ADDENDUM #1

PROJECT NAME: SCCAD Headquarters

CLIENT NAME: St. Charles County Ambulance District

PROJECT NO.: 18007

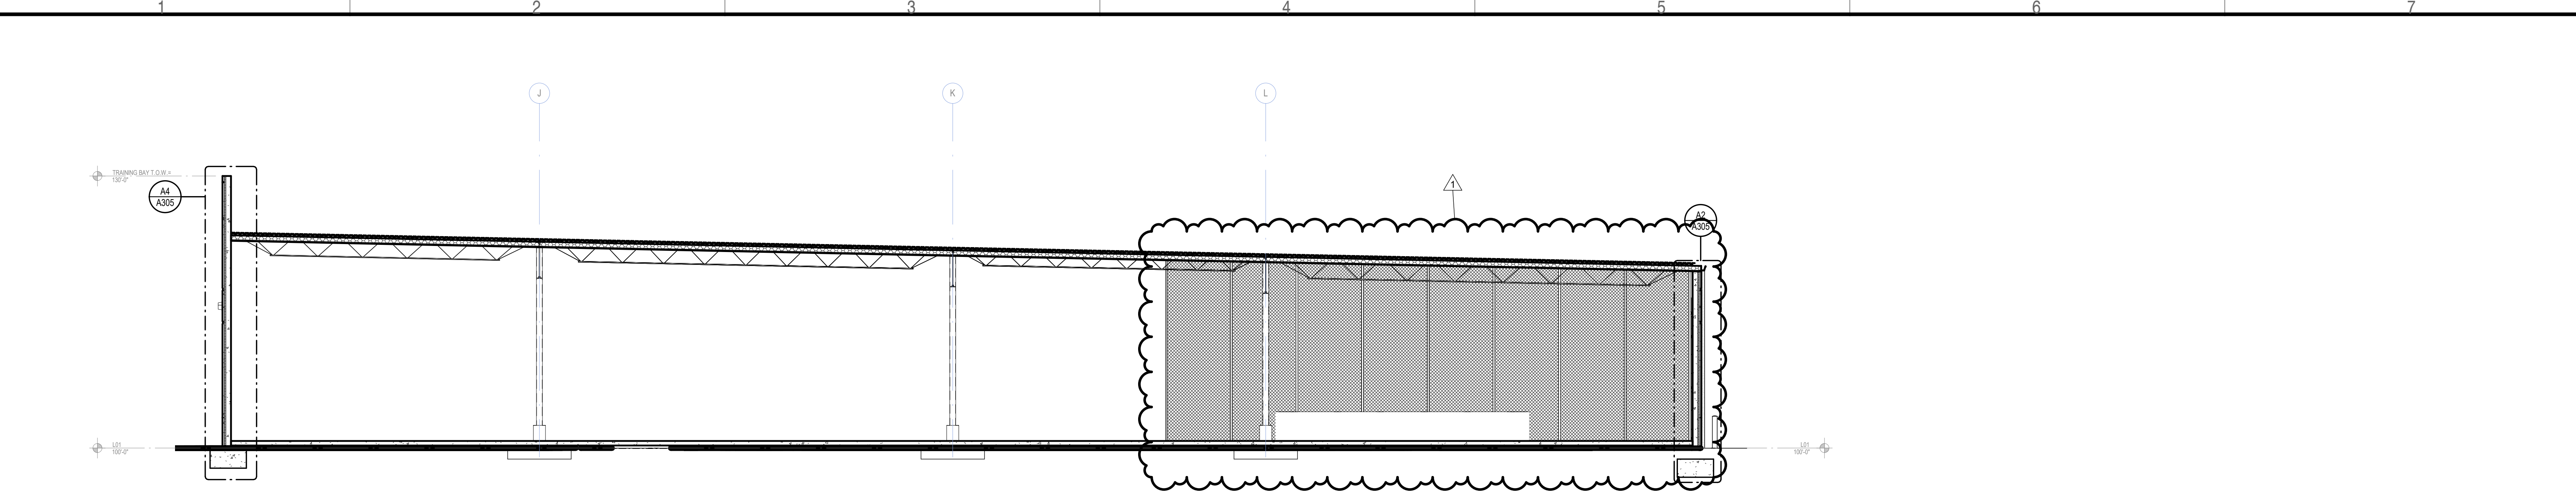
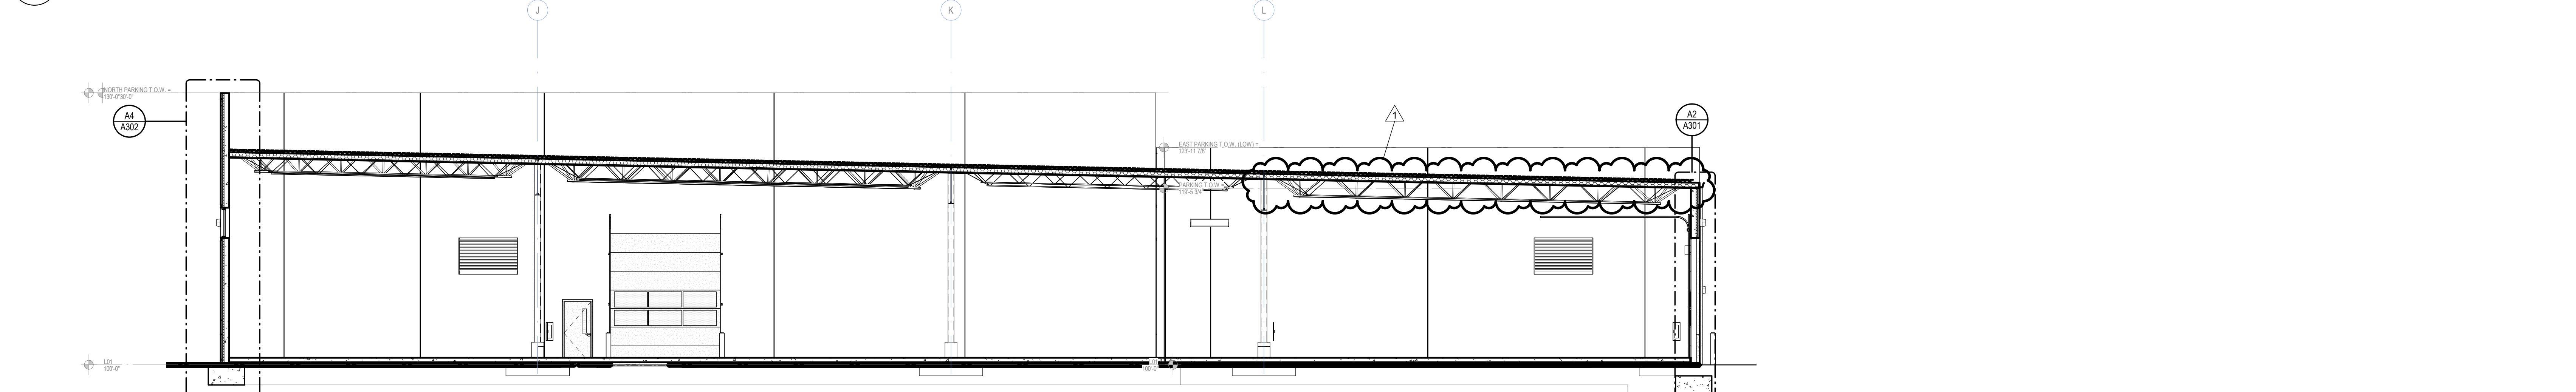
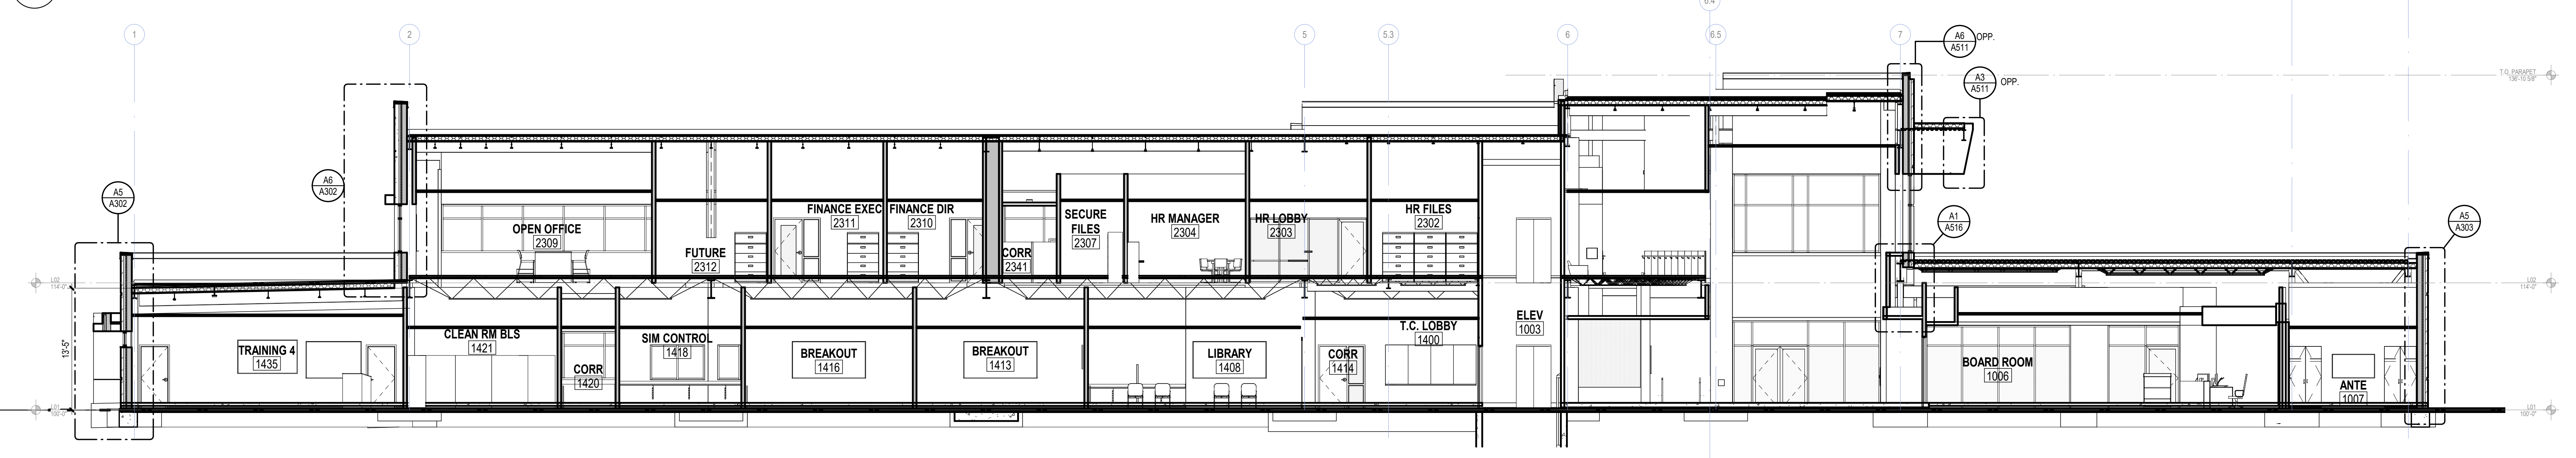
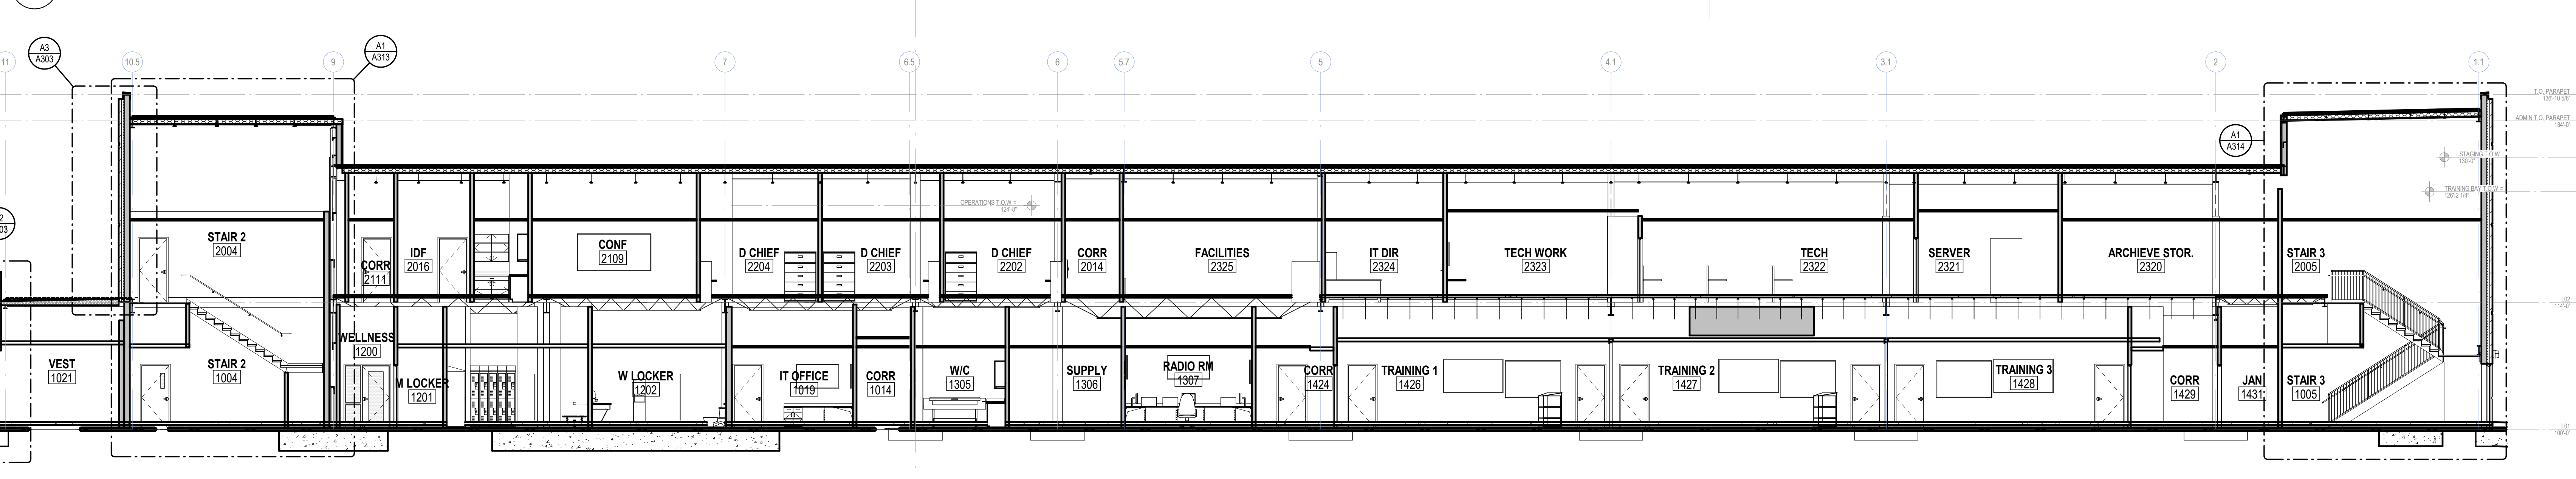
SHEET A211 – Building Sections

1. **C1 - Building Section – Parking**
 - REVISE – Truss depth
2. **D1 – Building Section – Parking**
 - ADD – Chain link fencing

Sheet No. **A414**

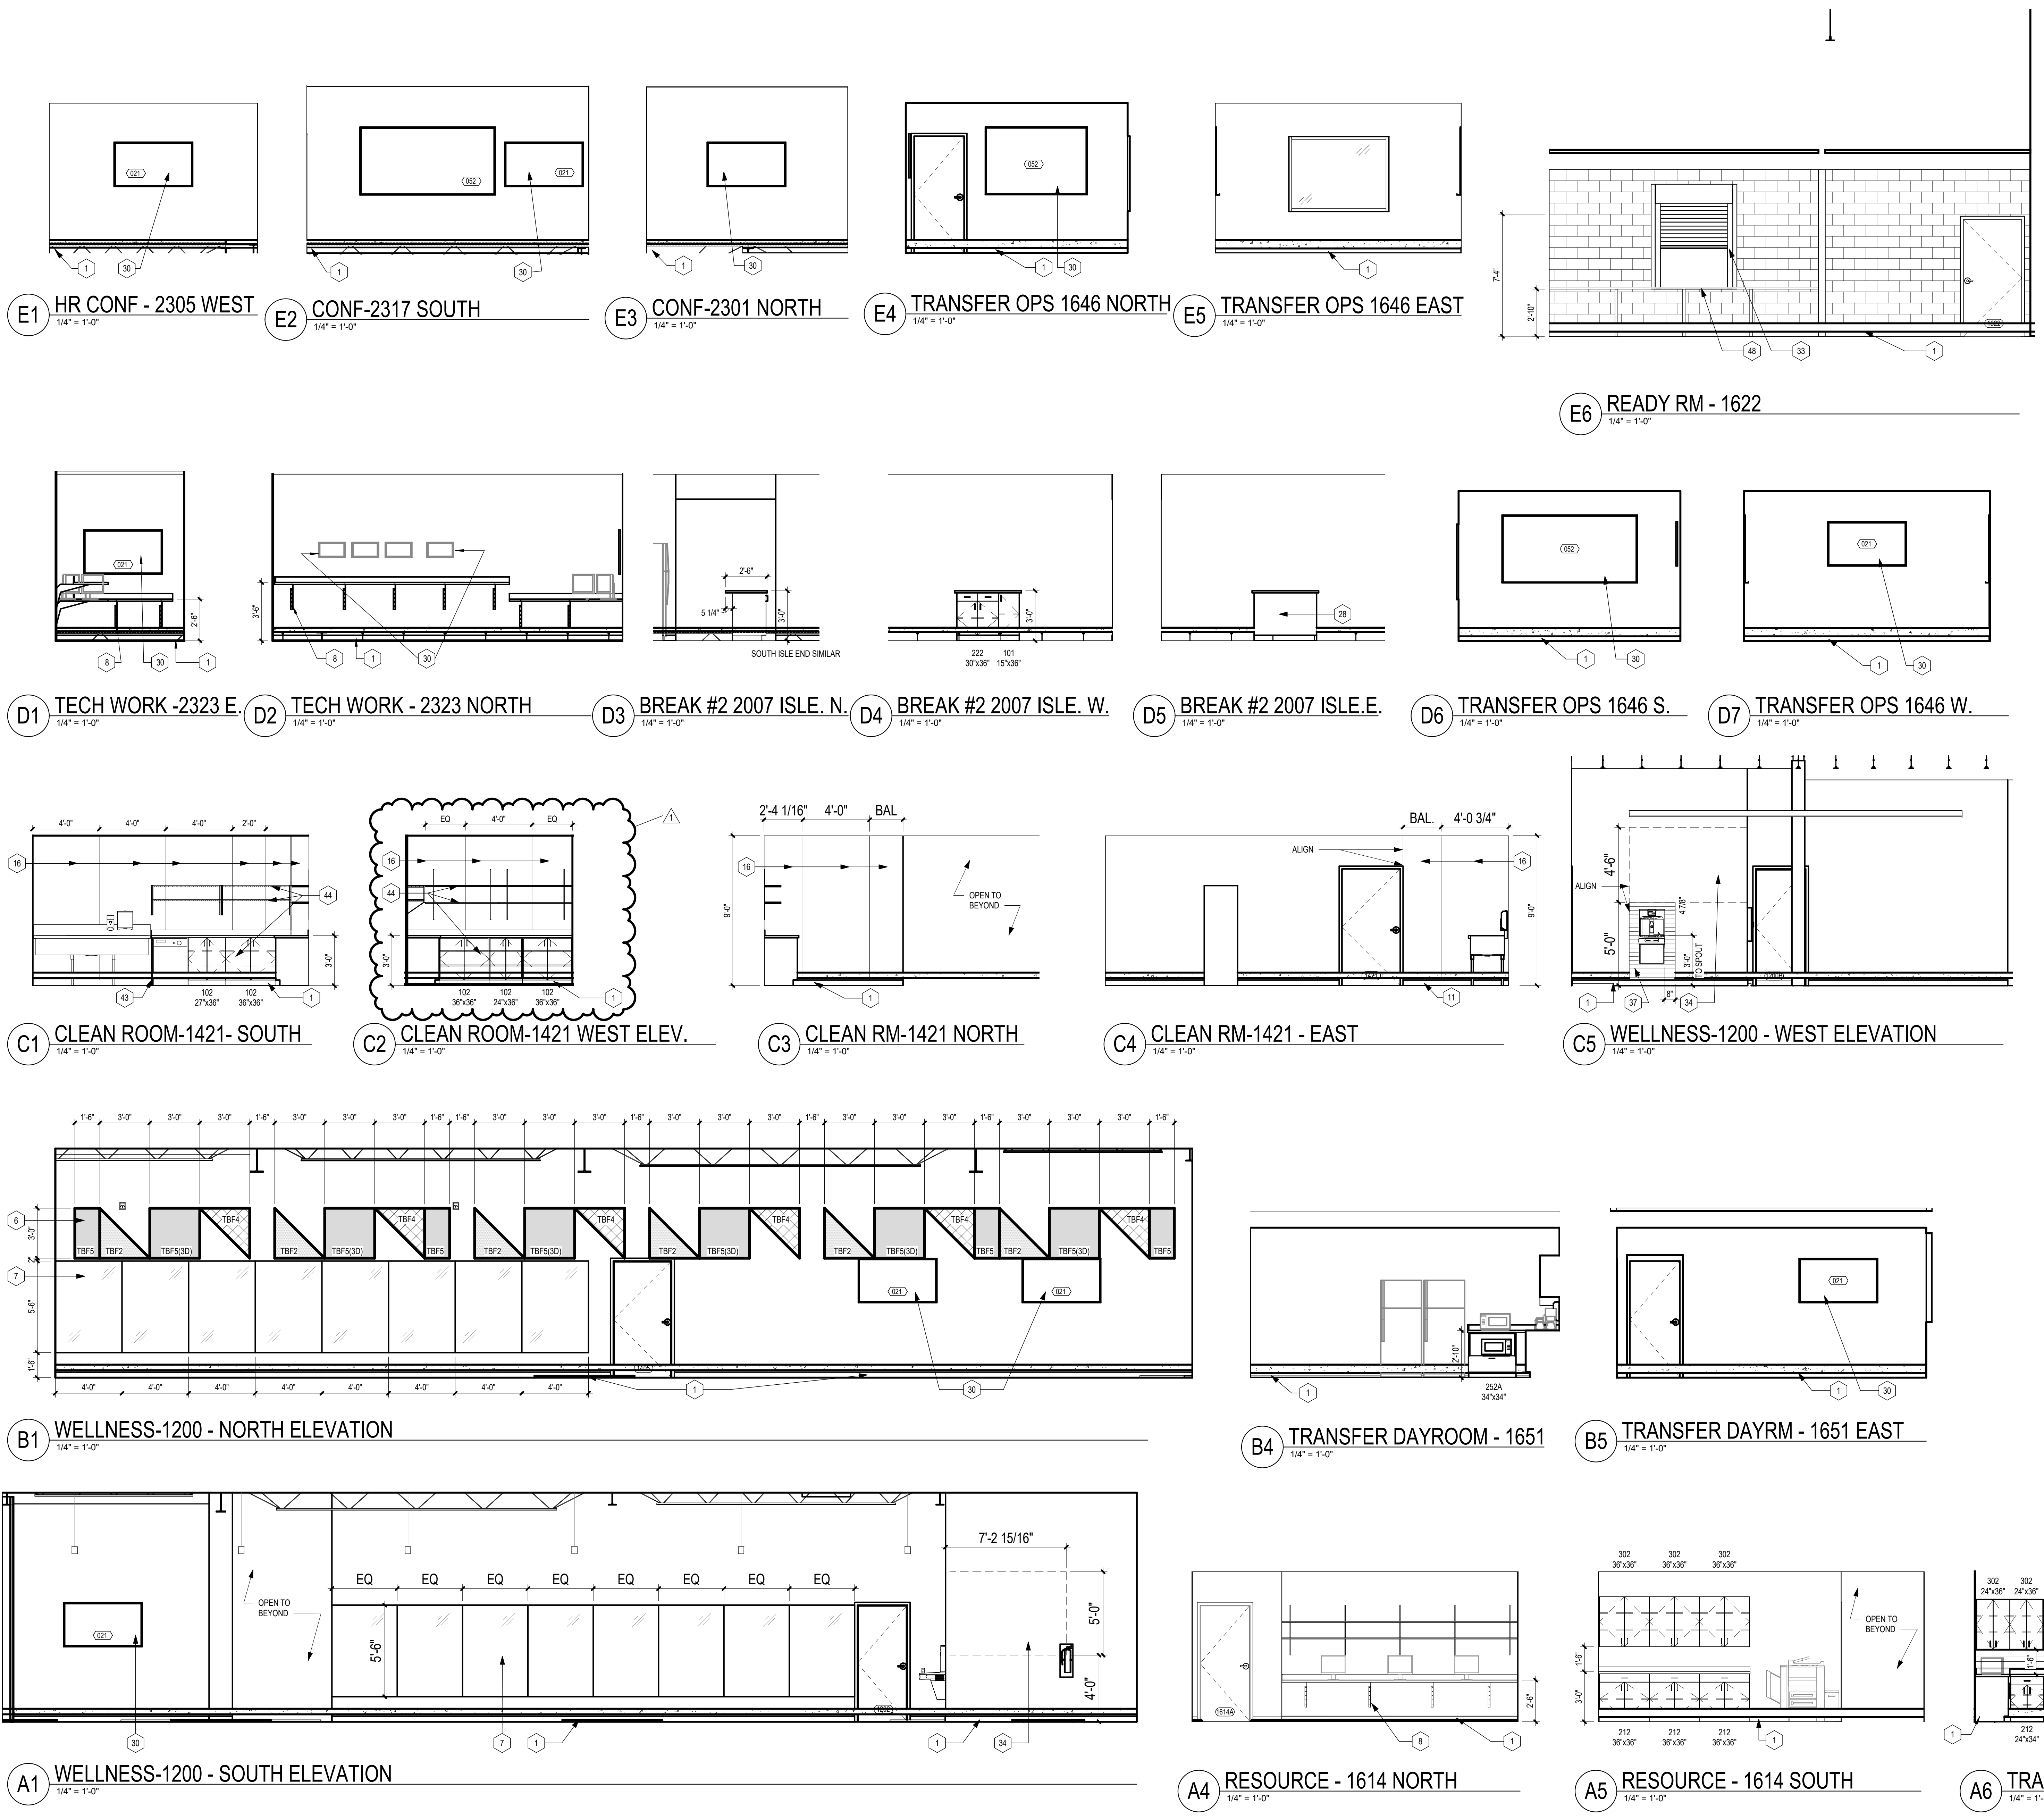
SHEET A414 – Interior Elevations

1. **C2 – Clean Room – 1421 West Elev.**
 - REVISE – Elevation
